## Technical Review of:

# *The Safer Affordable Fuel-Efficient (SAFE) Vehicles Rule for Model Years 2021-2026 Passenger Cars and Light Trucks*

## Final Report

October 25, 2018

Figure 1: BSFC map for 2018 PRIA\_Eng12 (93 Octane)

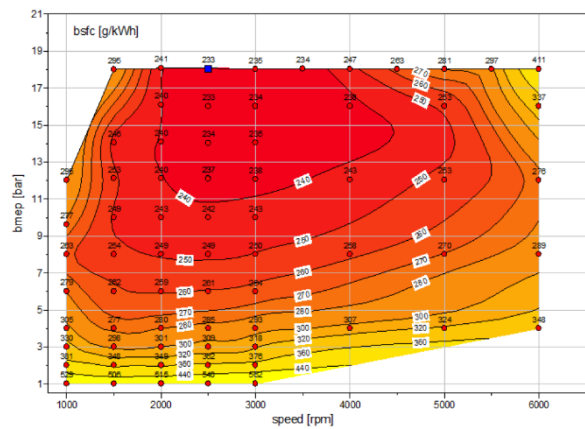
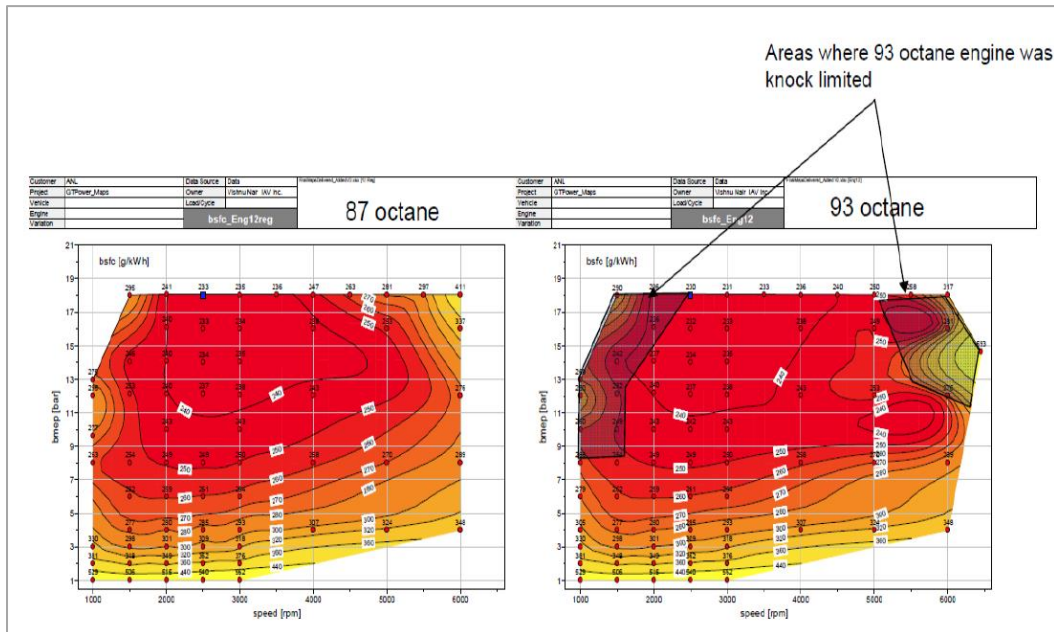
Several of the base engine maps used in the 2018 PRIA analyses exhibit maximum thermal efficiency (lowest fuel consumption) at 2000-3000 rpm and at maximum load, which is unrealistic for normal passenger vehicle engines. Such maps will overpredict fuel economy for extremely down-sized applications (very small engine in a heavy vehicle). This is because there is no fuel economy penalty for running the engine at high loads point where, in reality, BSFC is high due to retarding spark timing to prevent knocking and fuel enrichment to reduce exhaust temperatures to protect exhaust valves and turbocharger components.

Figure 3: PRIA\_Eng13 and -Eng14, downsized 1.2 liter with (left) and without (right) cooled EGR

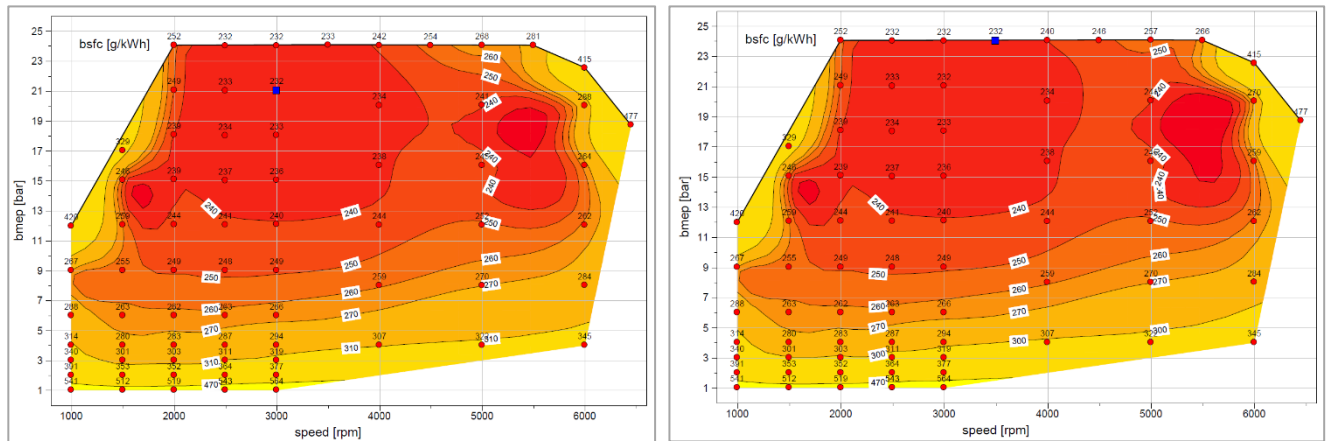
The 2018 PRIA analysis applies cooled EGR to turbocharged engines in an extremely narrow window at high engine speed and high load. The 2018 PRIA modeling erroneously excludes the application of cooled EGR in engine operating modes that highly influence overall vehicle fuel economy. This exclusion of the benefits associated with knock mitigation and reduced enrichment significantly understates incremental

improvement. The, Mazda 2.5L turbocharged SkyActiv engine exemplifies a wider-range cooled EGR strategy.

Figure 4: Shifting events

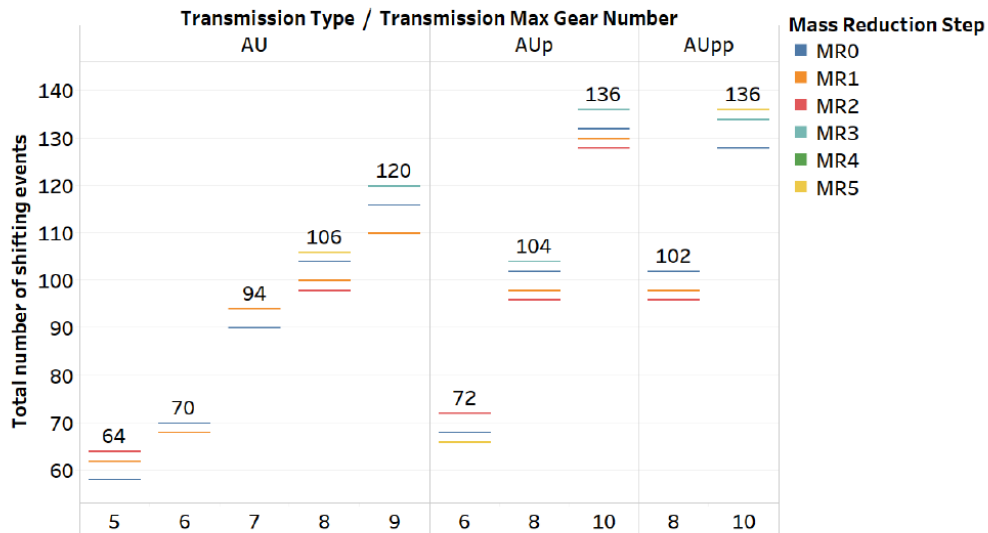
For some engine/vehicle combinations, the 2018 PRIA analysis calculates an extremely high number of transmission shifts (136 shifts) to occur during the US06 driving cycle. Such busyness would be completely unacceptable to passengers and over predicts the energy losses associated with such an extreme number of shifts.

Figure 5: BSFC Map of PRIA\_Eng12. 1.6L 4-cylinder base turbocharged engine (Source 2018 PRIA)

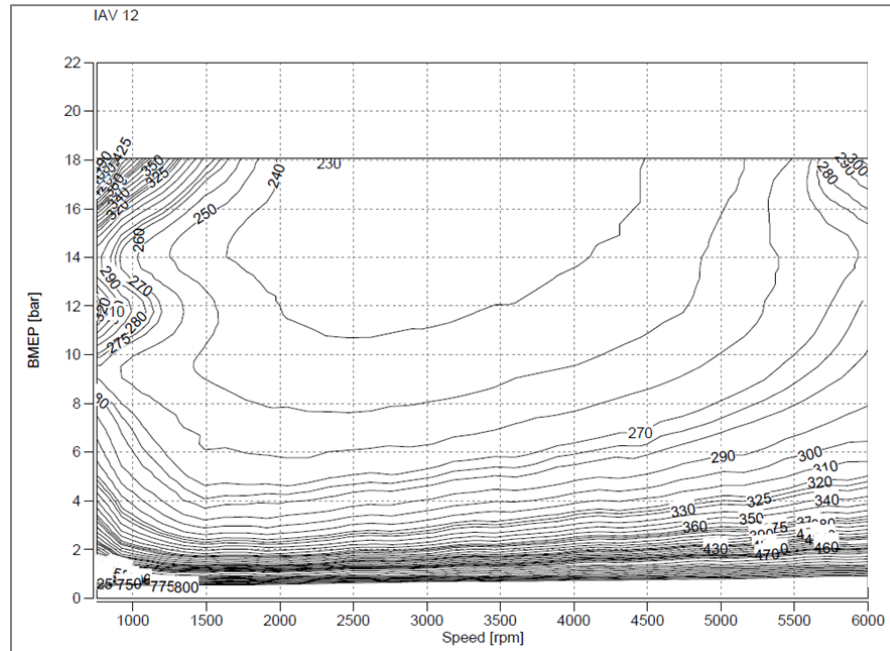
Figures 5, 6 and 7 allow a comparison of the brake-specific fuel consumption (BSFC) of the baseline turbocharged engine (PRIA\_eng12) used in the 2018 PRIA analysis to the Honda L15B7 1.5L engine available in the 2016 Honda Civic. The units of measure are grams of fuel consumed per kilowatt hour (g/kWh) of engine output; therefore, lower is better

The PRIA\_Eng12 turbocharged engine shown in Figure 5 is modeled with continuously variable valve lift (CVVL) on the intake side. This technology is relatively expensive<sup>13</sup> (>\$300.00 over VVT in MY2017) but is intended to improve fuel consumption by reducing the thermodynamic losses due to pumping work while operating at low power levels.

Review of contour shapes in Figure 5 shows that the PRIA\_Eng12 is predicted to have its highest efficiency at very high load and high engine speeds (up to 5,500 rpm). The engine map shows no degradation in BSFC at engine speeds between 2,000 rpm and 4,500 rpm, all the way up to peak load (18bar brake mean effective pressure: BMEP).

Figure 6: BSFC map of the Honda 1.5L L15B7 Engine used in the 2016 Honda Civic

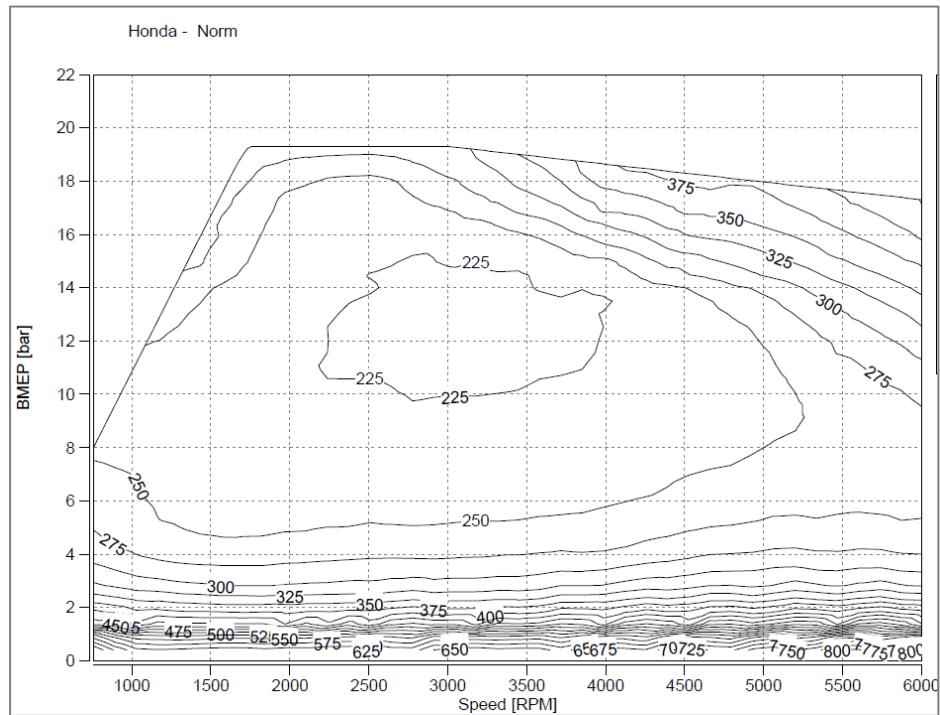
Figure 6 shows a similar BSFC map for the Honda L15B7 turbocharged engine<sup>14</sup> that has continuously variable intake and exhaust camshaft phasing (CVVT) which is less expensive than CVVL. Figure 7 shows the mathematical difference between the maps.

Comparison of these fuel consumption maps shows that the Honda engine is almost 10% more efficient over a significant portion of the map that is most relevant to fuel economy test cycles. Also, since the L15B7 is the first generation of the new Honda turbocharged engine, even further fuel consumption improvement is highly likely in the period through MY2025.

Figure 7: Delta (Honda 1.5L L15B7 – PRIA\_Eng12)

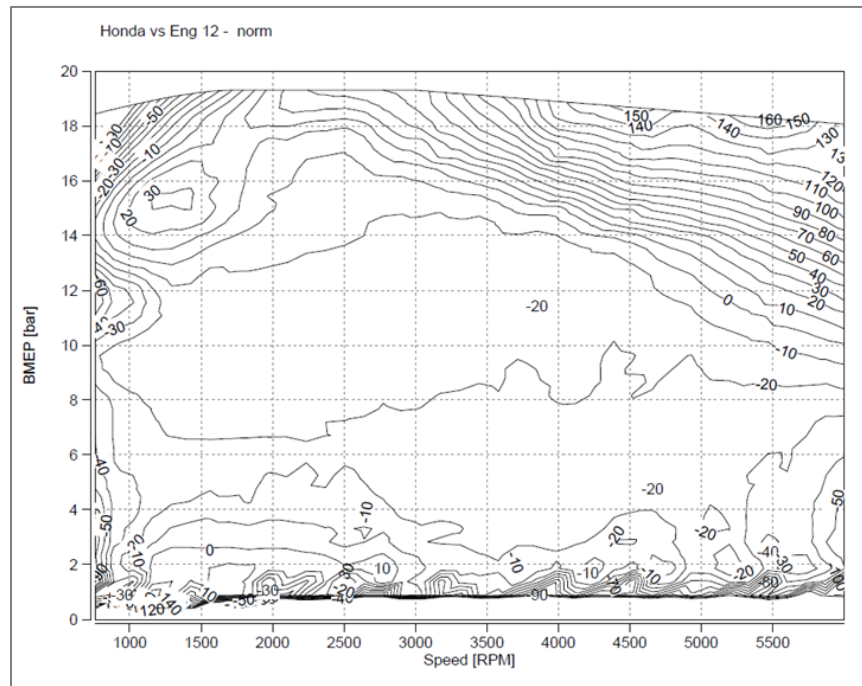
This behavior is unrealistic because turbocharged engines at high loads require retarded spark timing to prevent knocking and fuel enrichment to prevent overheating of turbocharger and related components. These factors will increase fuel consumption and reduce efficiency under real-world conditions.

Another effect of this unrealistic fuel consumption curve would be to predict unreasonably good fuel consumption at very high power levels for downsized turbocharged engines. This could bias technology pathways in over-predicting fuel economy benefits for small engines installed in heavier engines. The predicted performance of the vehicle (drivability, acceleration, fuel consumption, etc.) would be overly optimistic, creating unrealistic real-world pathways.

Figure 8: BSFC Map of PRIA\_Eng 13: 1.2L I4 Turbo DI with Cooled EGR (Source 2018 PRIA)

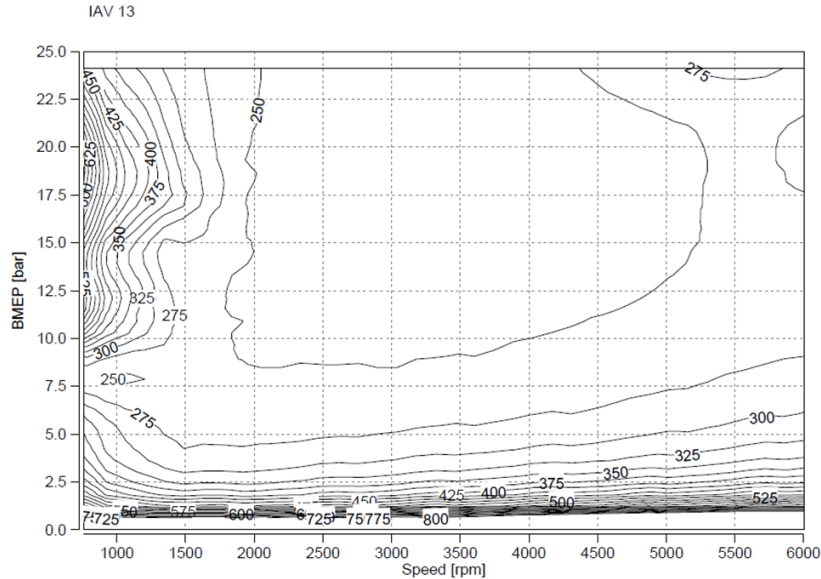
Figure 8 shows the BSFC map of the PRIA\_Eng13 which is a 1.2L, I4 turbocharged, VVT, DI engine with cooled EGR. For comparison, Figure 9 shows the BSFC map for the Mazda 2.5L SkyActiv Turbo engine<sup>15</sup> which is available in the MY2016 Mazda CX-9 which also employs cooled EGR. Figure 10 shows the mathematical difference between the two BSFC maps, with all three figures using measurement units of grams of fuel consumed per kilowatt hour (g/kWh) engine output.

Review of the figures shows that the BSFC of the Mazda turbo engine is about 20 g/kwh (about 10%) less than the PRIA\_Eng13 engine over a significant portion of the test-cycle-relevant engine operating range (low and medium speed and loads). This would likely result in a fuel economy improvement of at least 10%, especially after proper mating of transmission gear ratios.

As was the case with PRIA\_Eng12, the PRIA\_Eng13 turbocharged engine with cooled EGR shows unrealistically high efficiency (unreasonably low BSFC) at the highest load (23bar BMEP) over a broad speed range from 2,000 rpm to over 5,000 rpm. At these very high loads, there is still the need to retard spark timing for knock control and perhaps a greater need for enrichment based upon the very high load level (>23bar).

Figure 9: BSFC map of 2016 Mazda SKYACTIV-G Turbo 2.5L I4

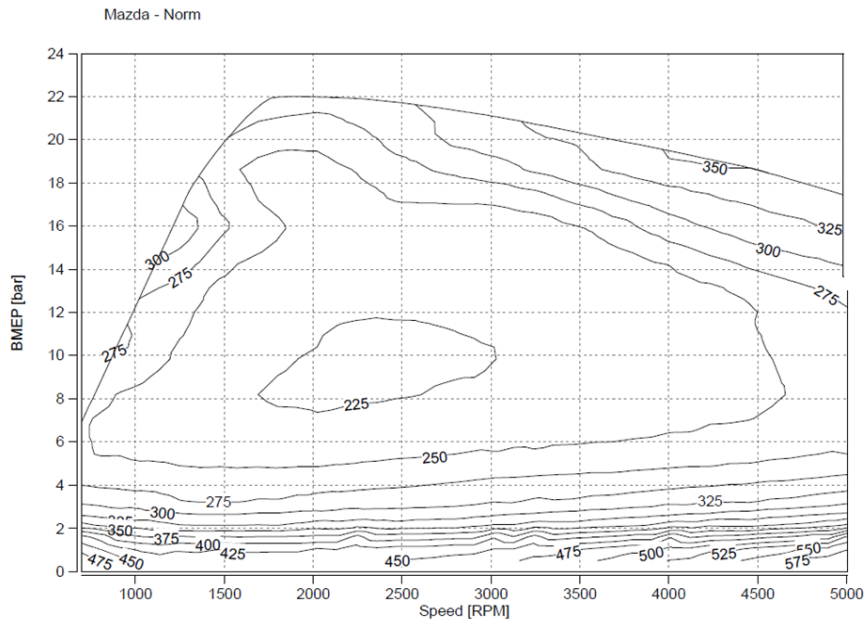
Therefore, a realistic engine will exhibit minimum fuel consumption “islands”, such as is shown Figure 9 for the Mazda SkyActiv engine.

Figure 11: Predicted Fuel Economy for Toyota RAV4 AWD I4

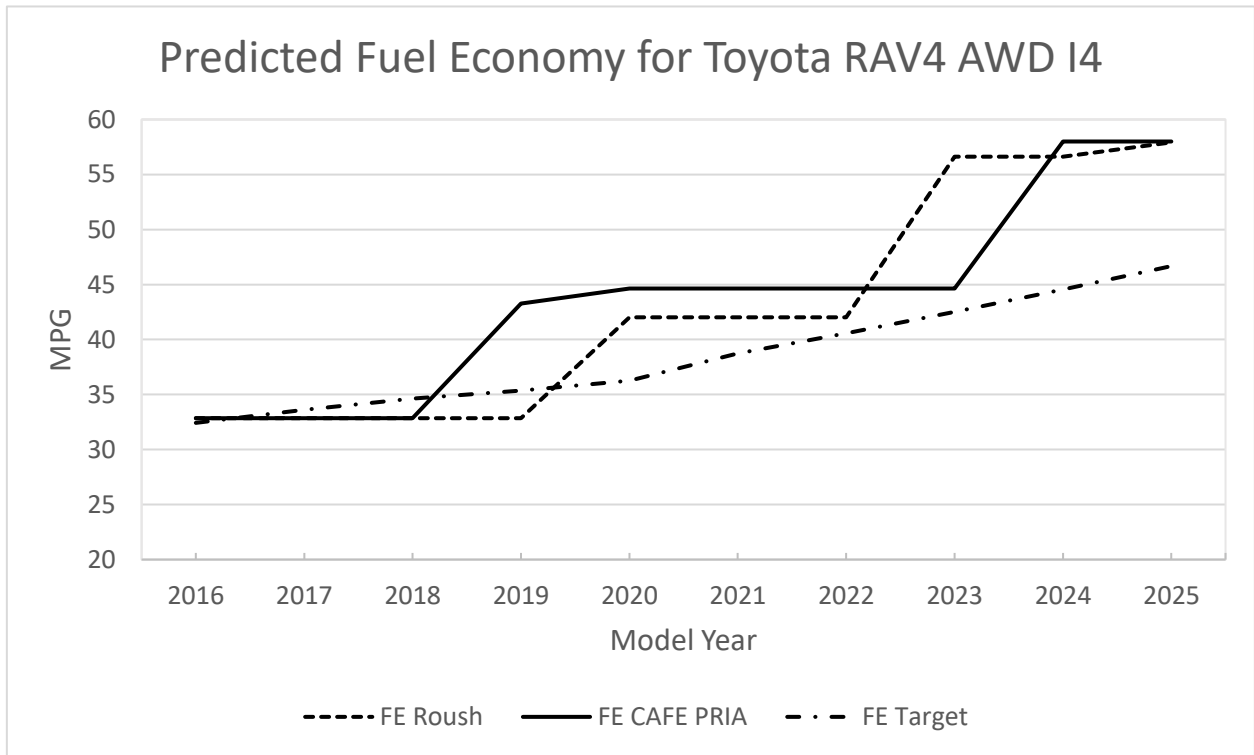
The results from the analysis are further presented in Figure 11 where the incremental fuel economy improvement is plotted versus vehicle model year, for both the 2018 PRIA results and the Roush results for a Toyota RAV4 AWD. Also shown is the target CAFE fuel economy by model year based upon the footprint of the RAV4.

The results show that the use of proper engine and transmission maps, which are optimized depending upon the engine characteristics, combined with engine displacement and gear ratio optimization as vehicle weight is reduced, predict that compliance with augural 2025 standards can be achieved without the application of P2 hybridization, which was chosen by the 2018 PRIA CAFE model

Figure 12: Accumulated Cost to Comply with MY2025 CAFE for Toyota RAV4 AWD I4

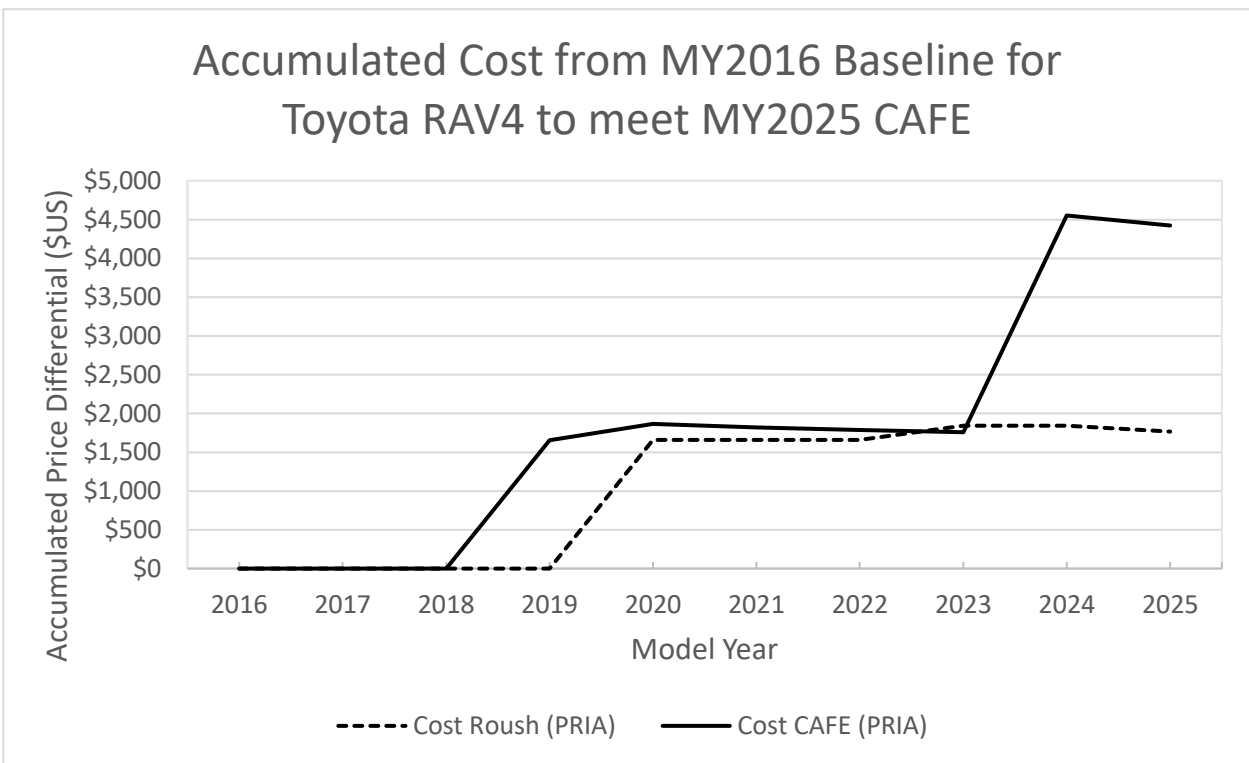
Figure 12 presents the accumulated cost by model year to achieve the fuel economy values summarized in Table 4 and presented in Figure 11. Again, the 2018 PRIA projection for the RAV4 is compared to the Roush analysis.

The purpose of this analysis is to show that proper design optimization of engine and transmission subsystems, combined with reasonable estimates for incremental improvement, especially with the BISG, results in a predicted cost which is 60% less than that of the CAFE model.

Figure 13: Predicted Fuel Economy for Ram 1500 4x2 V6

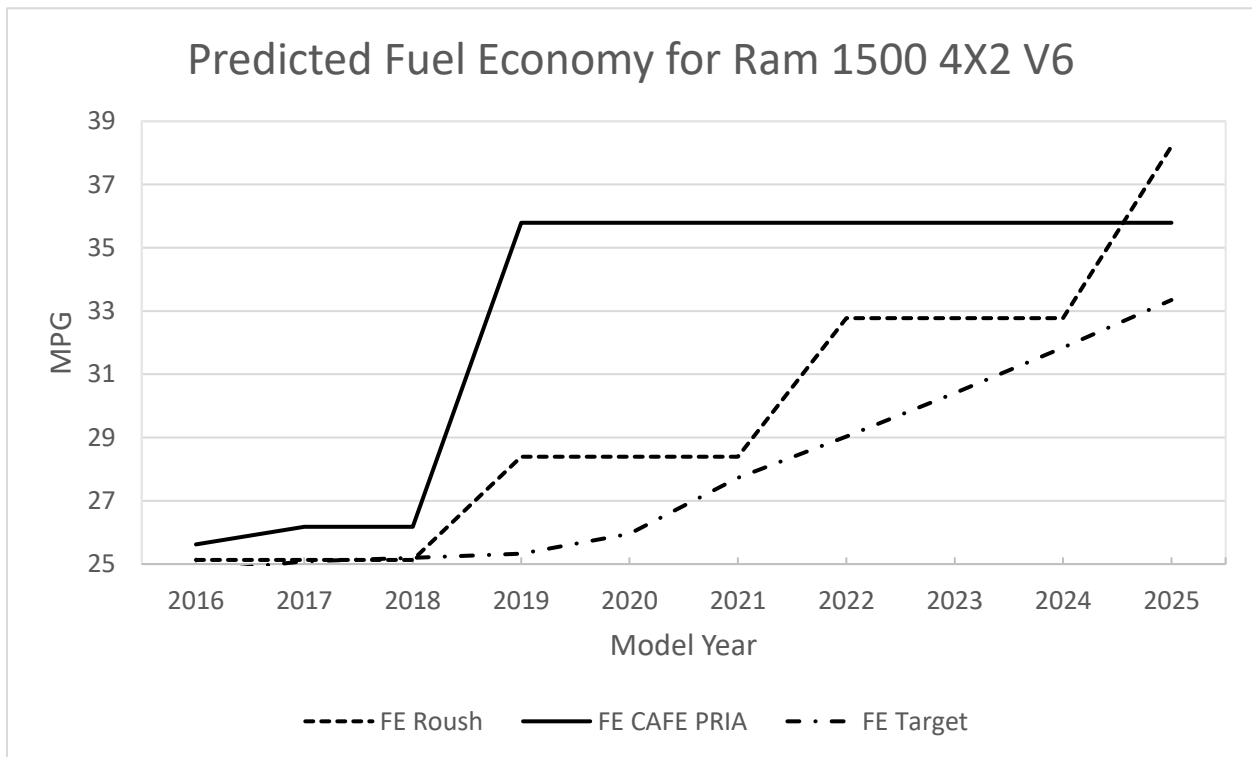
The results from the analysis are further presented in Figure 13 where the incremental fuel economy improvement is plotted versus vehicle model year, for both the 2018 PRIA results and the Roush results for the Ram 1500 4x2 V6, together with the target CAFE FE model year. Figure 14 presents the associated accumulated cost by model year to achieve the FE values summarized in Table 5 and presented in Figure 13.

The 2018 PRIA CAFE model predicts compliance with the MY2025 augural standard of 33.3 mpg, by achieving 35.8 mpg, at a predicted cost of \$3,371.87 in 2025. This technology pathway follows downsized turbocharging with cooled EGR and a 48V BISG.

The Roush proposal is shown to achieve an even greater fuel economy level, at 38.2 mpg by MY2025, and exceed the augural standards each year from MY2016 to MY2025. This is accomplished at an incremental cost of \$2,359.52 in MY2025, which is over \$1,000.00 less expensive, or a projected cost reduction of over 30%.

Figure 14: Accumulated Cost to meet MY2025 CAFE for Ram 1500 4x2 V6

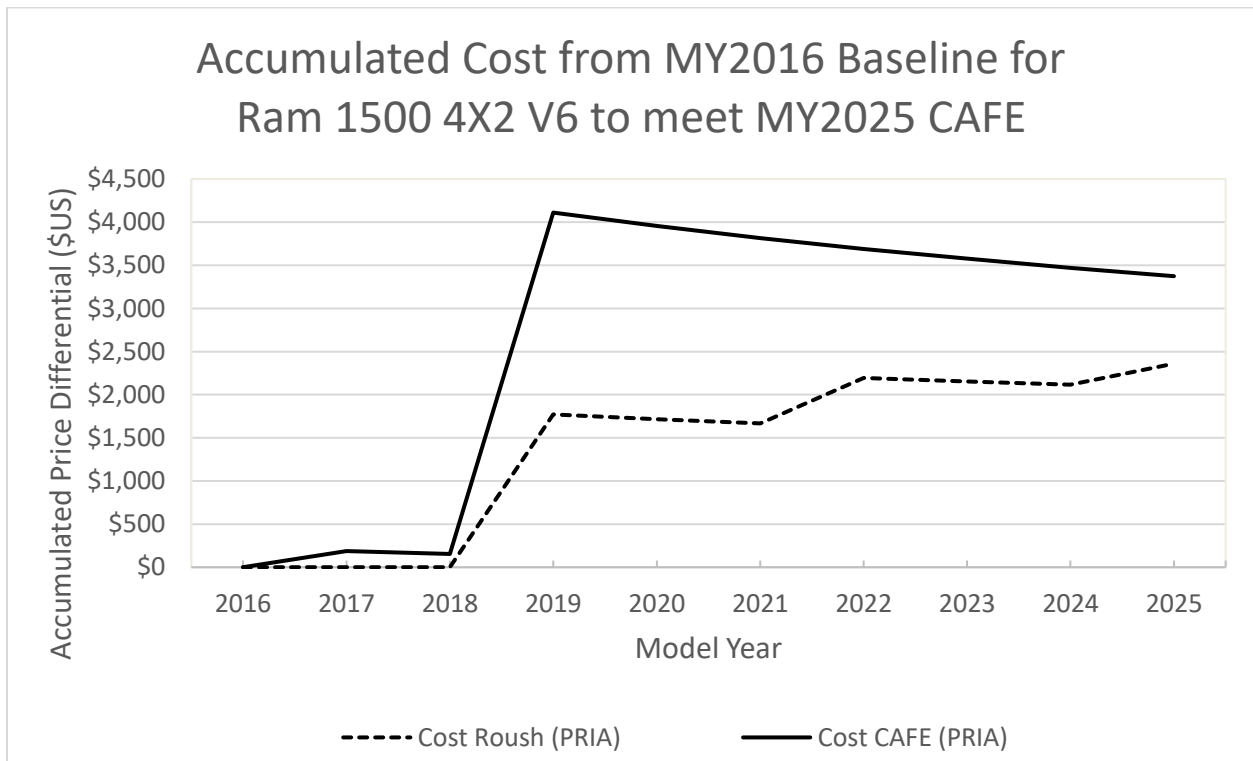
This analysis further exemplifies the compounding issues associated with inaccurate engine and transmission shift maps, lack of retuning transmission and differential gear ratios as engine parameters change, the use of accurate effectiveness levels, improper CAFE Model constraints and overstated incremental costs.
